DECISION OF THE PLANNING ADMINISTRATOR

CLASS 3 SITE PLAN REVIEW AND CLASS 2 ADJUSTMENT CASE NO.: SPR-ADJ24-30

SUMMARY: A Class 3 Site Plan Review with Class 2 Adjustments to increase the maximum height for five light poles.

Subject: **Site Plan Review and Adjustment Review (24-116629-PLN)**
Supplemental Information Response to Public Comments

LAND USE
SHEET TITLE
BIKE PARKING PLAN
SHEET #

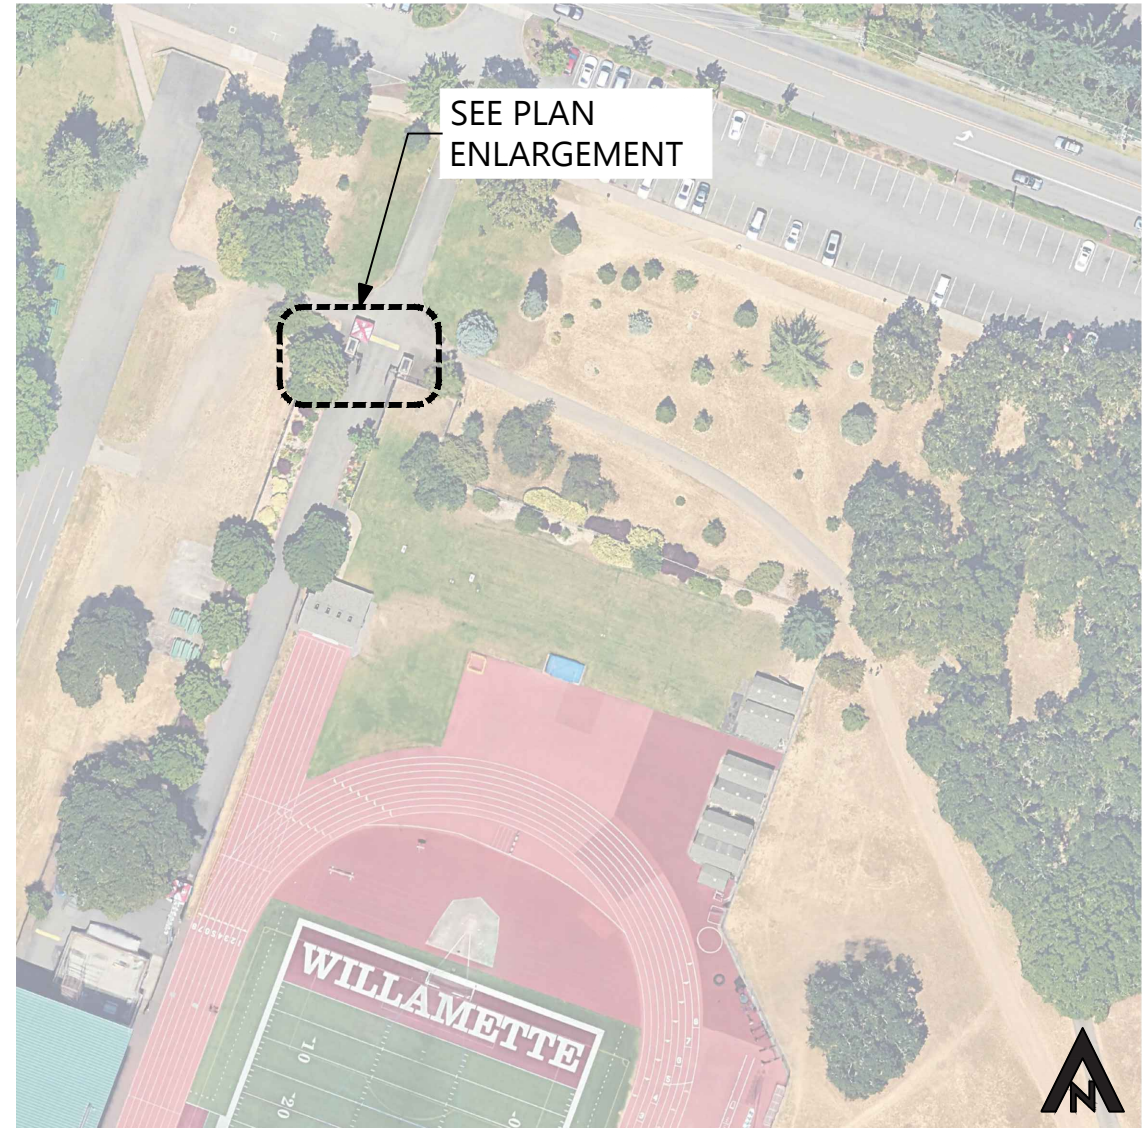
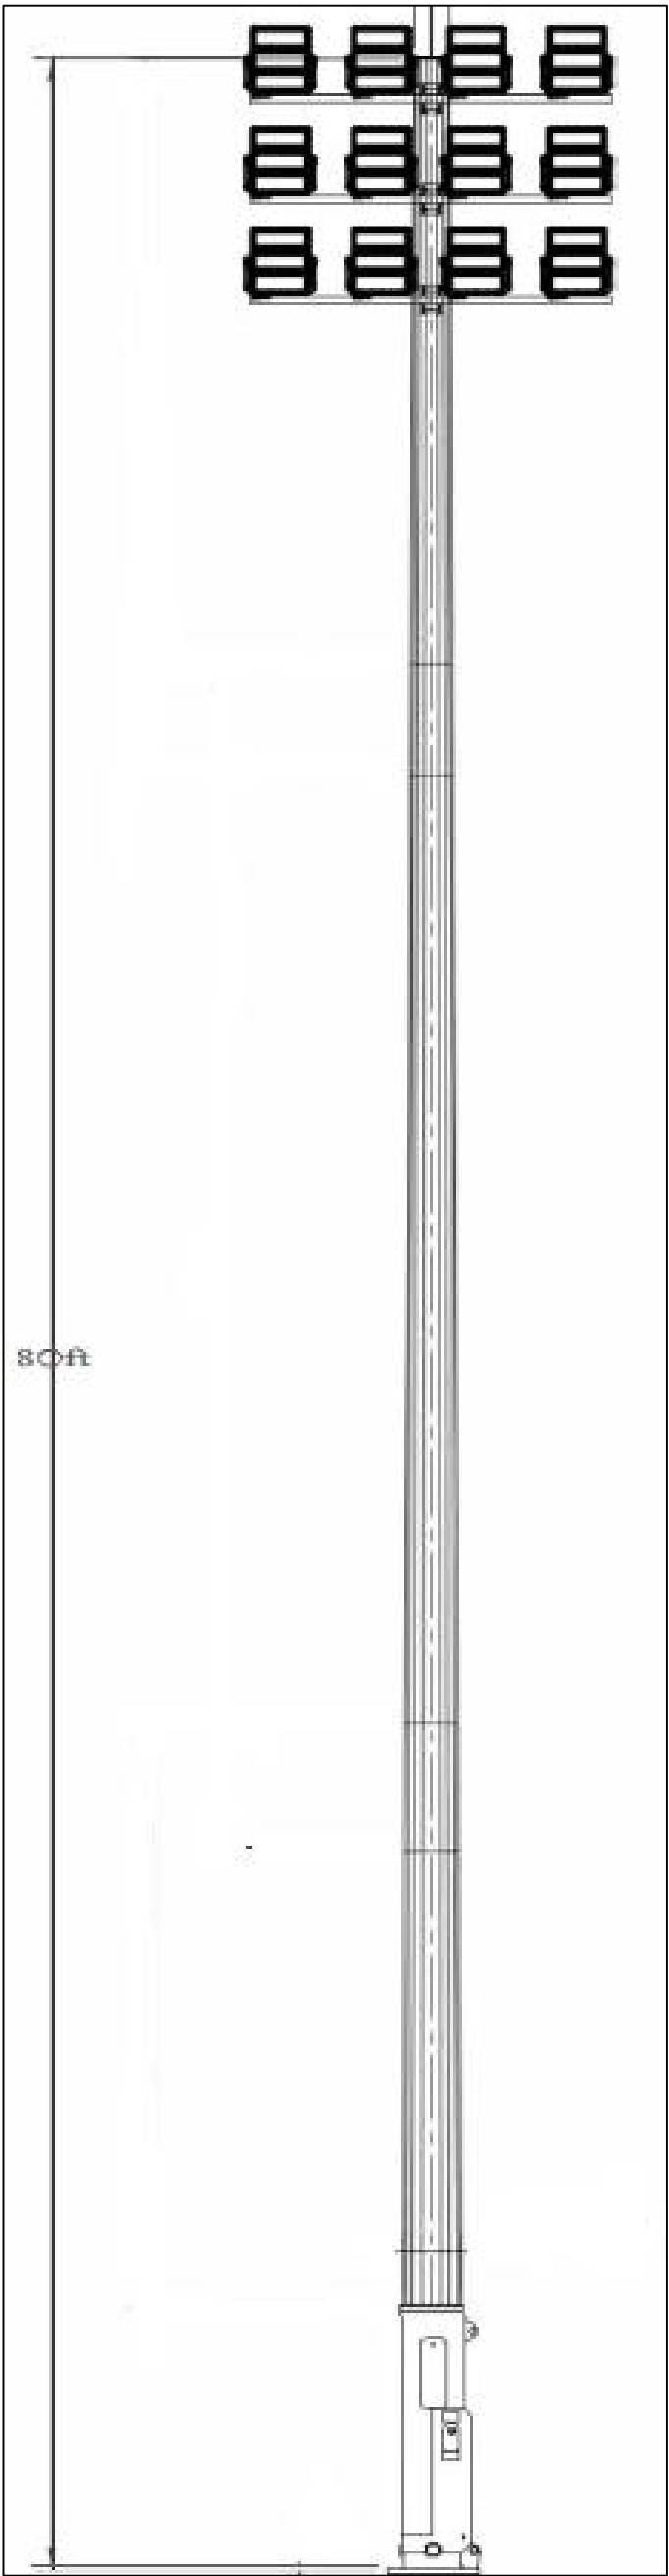
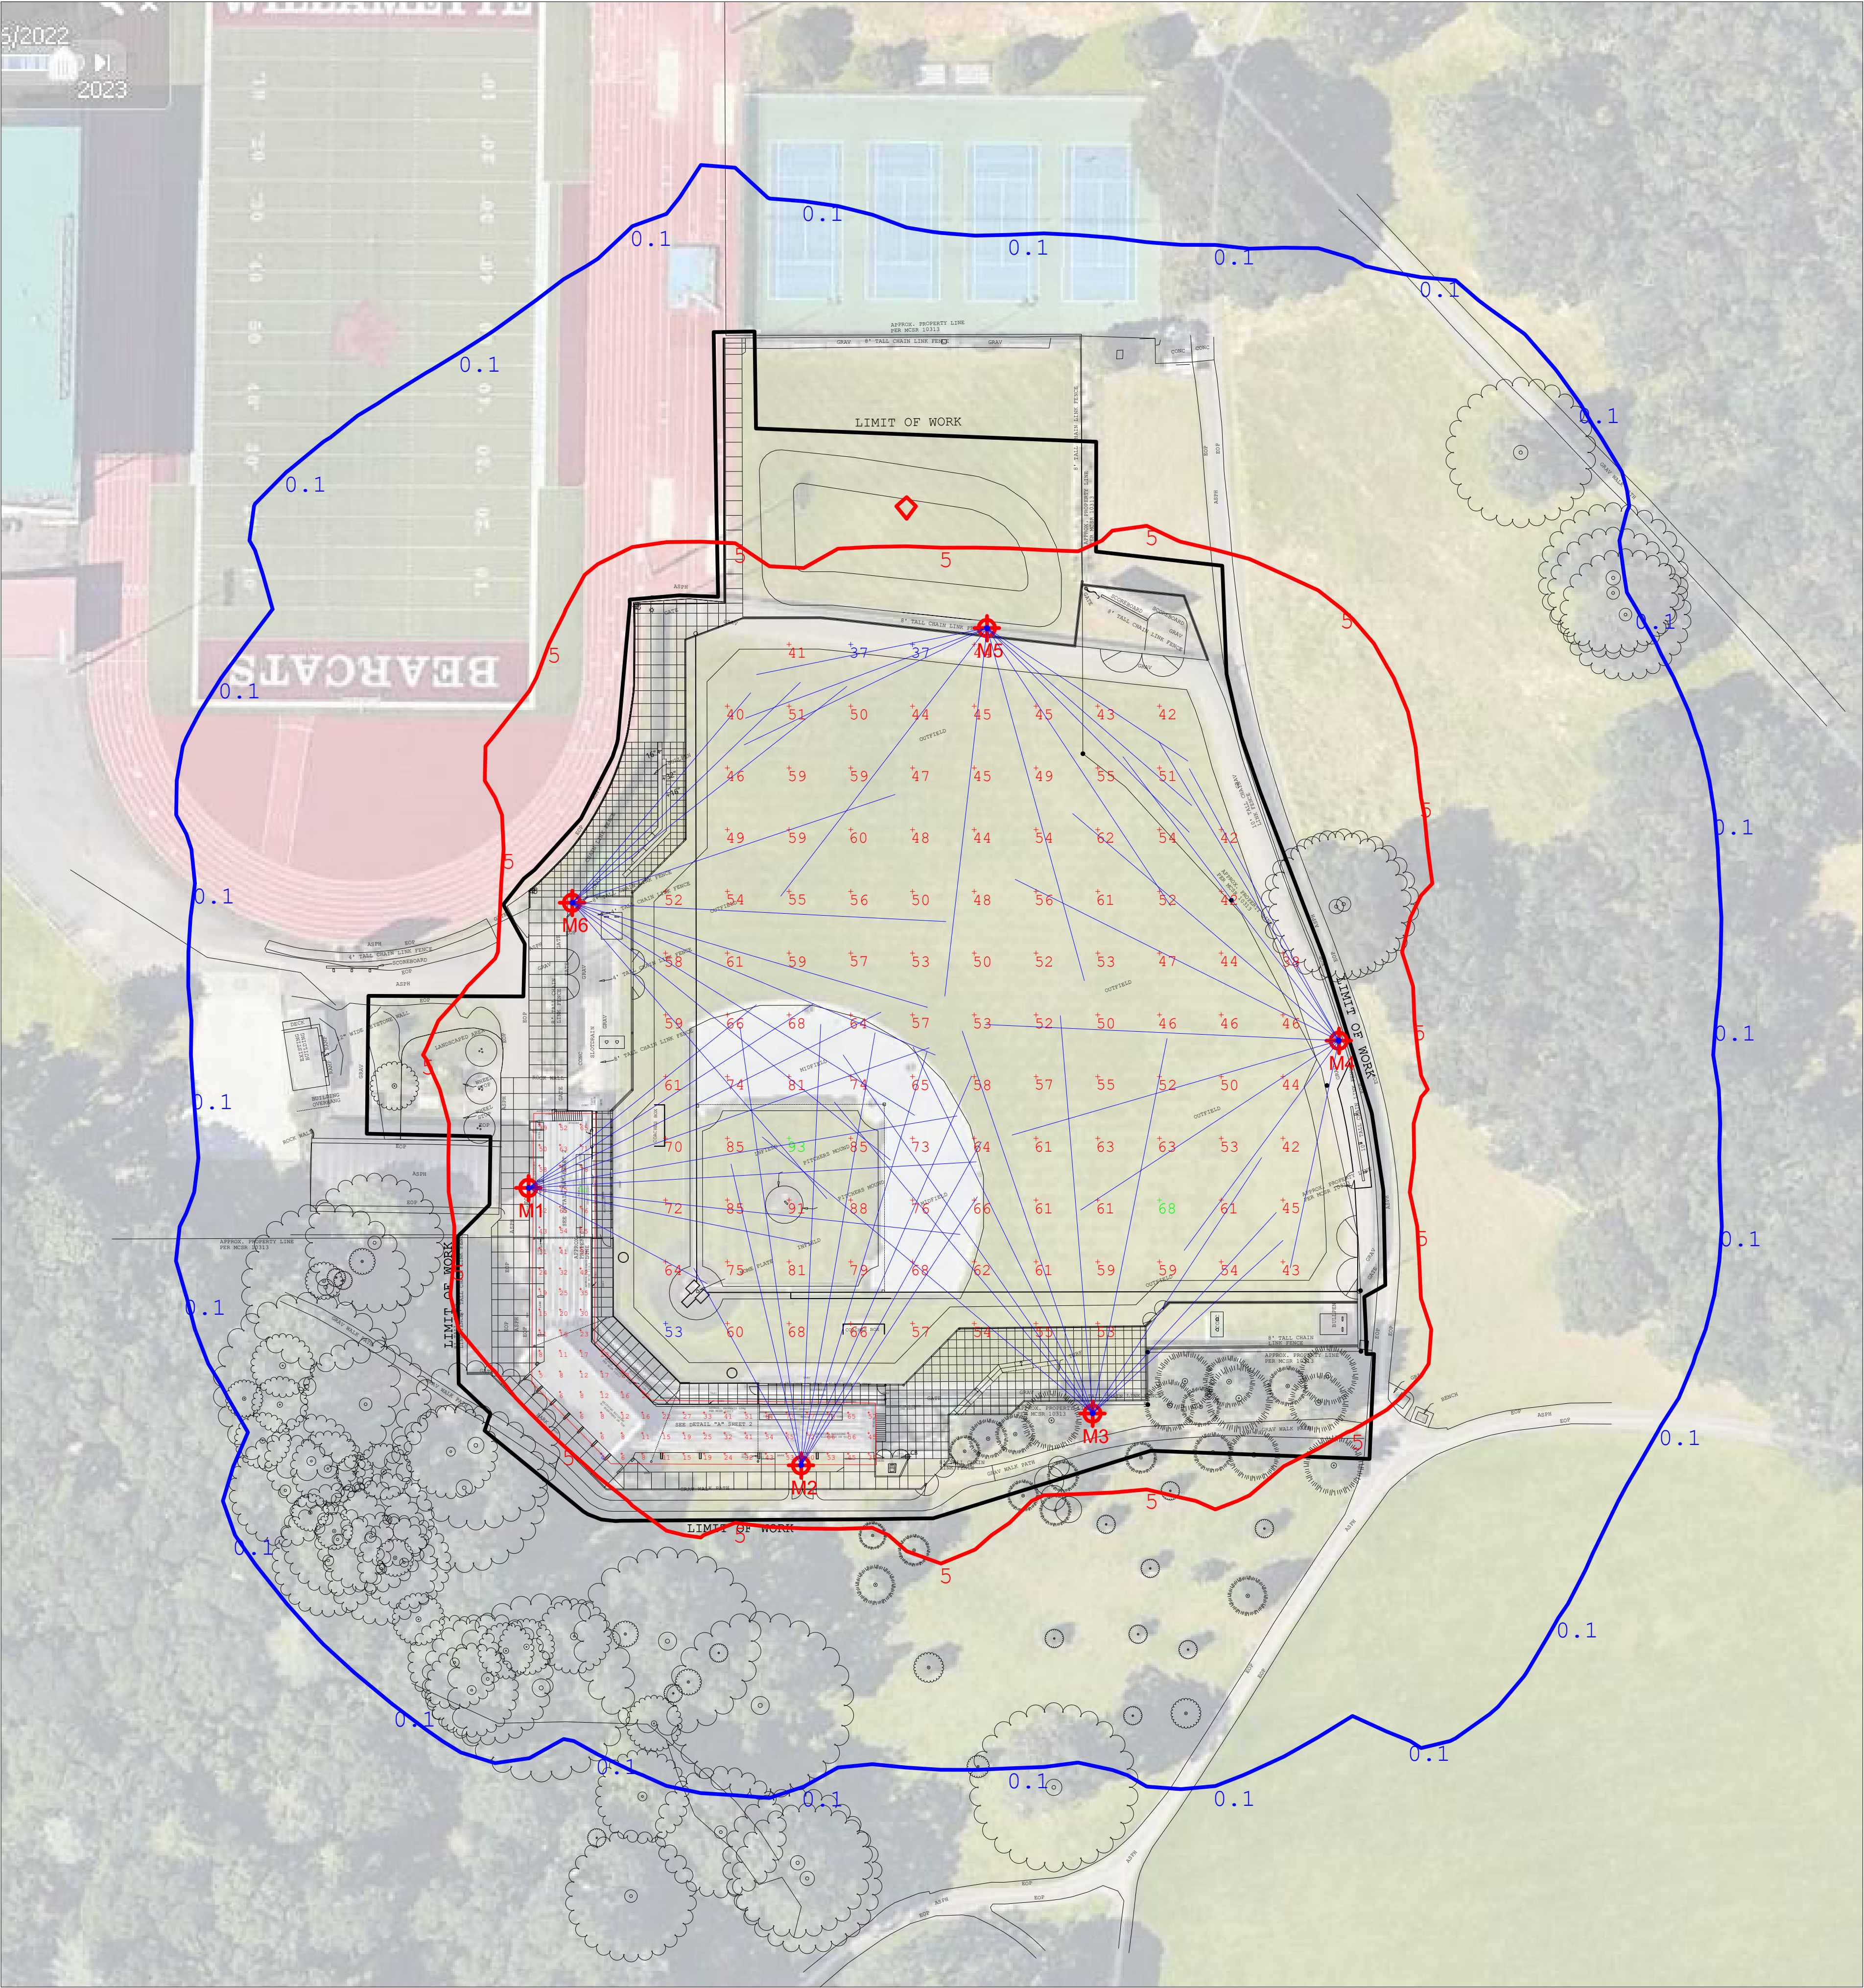
Bike Parking: Comments were submitted regarding the location of the bike parking for the facility. Bike parking near the southern gate, near the soapbox Derby Hill, Leffelle parking area and tennis courts was requested.

Private citizens request that the location of the proposed bike racks be revised to include racks near the entry gate south of the stadium; near the existing tennis courts; near the top of Derby Hill; and near the lower Leffelle parking area.

Staff Response: The applicant is required to provide adequate bicycle parking *on-site* meeting the requirements of SRC 806.060. The subject property only has a single access point abutting a public street, which is Mission Street SE. Bicycle Parking is required to be located on-site and meet the standards for location and access outlined in SRC 806.060. Willamette University does not have the authority to locate bicycle parking within Bush's Pasture Park. General bicycle parking requests for the park have been forwarded to the City Parks staff for review and consideration. As conditioned, below the applicant will be required to provide adequate bicycle parking consistent with SRC 806.060.

Condition 1: At the time of building permit, the applicant shall show a minimum of 62 bicycle parking spaces to be installed on the development site in conformance with the requirements of SRC 806.060.

As specified in the Restated Agreement between Willamette University and the City of Salem (Exhibit E), all site improvements must be within the boundaries of the property owned by Willamette University and/or the area established in the agreement. As part of site improvements, the Applicant will provide the amount of bicycle parking required in accordance with Sec. 806.055 and develop and maintain bicycle parking in accordance with Sec. 806.060.

80ft Mast for up to 12 Fixtures

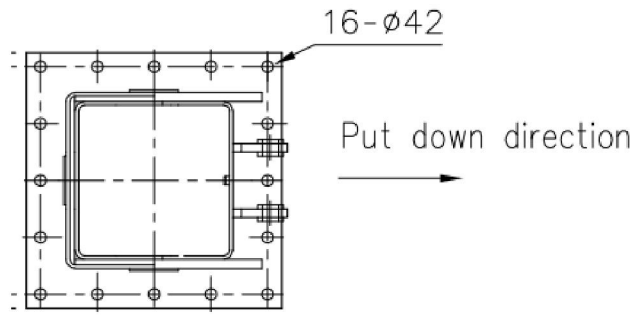
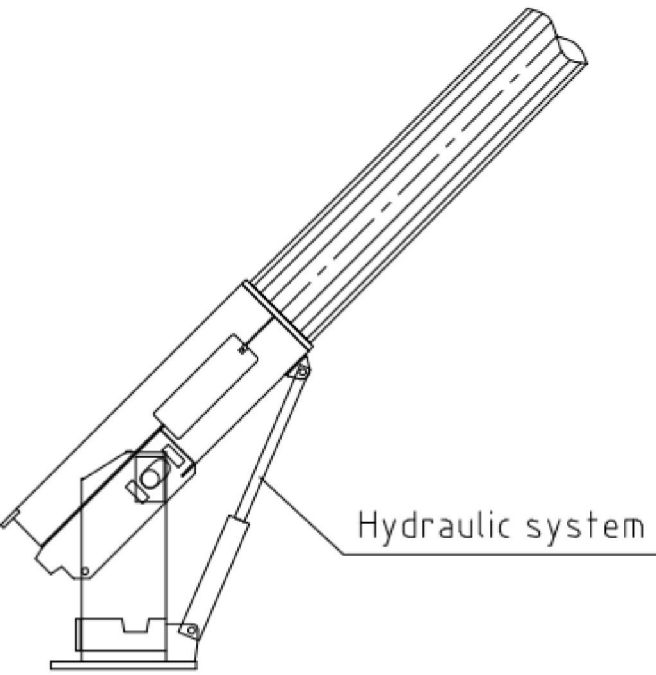
Light Nuisance: There are comments submitted regarding the height of the new light pole and the possibility of light nuisance to surrounding documents.

Private citizens request that the Adjustment Review findings affirm that the period of significance for the Historic District does not apply to the proposed field lighting fixtures. The comment also requests that the light fixtures comply with exterior lighting standards, and that the lights only be used when necessary during night games and turned off after each game.

Staff Response: Light Nuisance and the Class 2 Adjustment to increase the height of the light poles is addressed below in Section 7 of this report. The fixtures are specifically designed to minimize light pollution and are finished with a dark aluminum color to blend with the surrounding landscape. The proposed field lighting specifications demonstrate compliance with SRC 800.060, with a 0% upward light ratio and one footcandle in illumination at 3-feet above ground level at a distance five feet outside the project limits.

Condition 2: All lighting shall not shine or reflect more than five-feet outside of the subject property (including the leased area), shall not illuminate more than five foot-candles and lighting shall be directed towards the field.

Compliance with SRC 800.060 Exterior Lighting Standards is required for Site Plan Review approval. The submitted Site Plan Review application addresses exterior lighting requirements (Written Statement_R1, Section 6.1, page 16). Exhibit G (Lighting Specifications) supports these findings with diagrams and calculations demonstrating a 0% upward light ratio and no illumination visible outside the property boundaries.
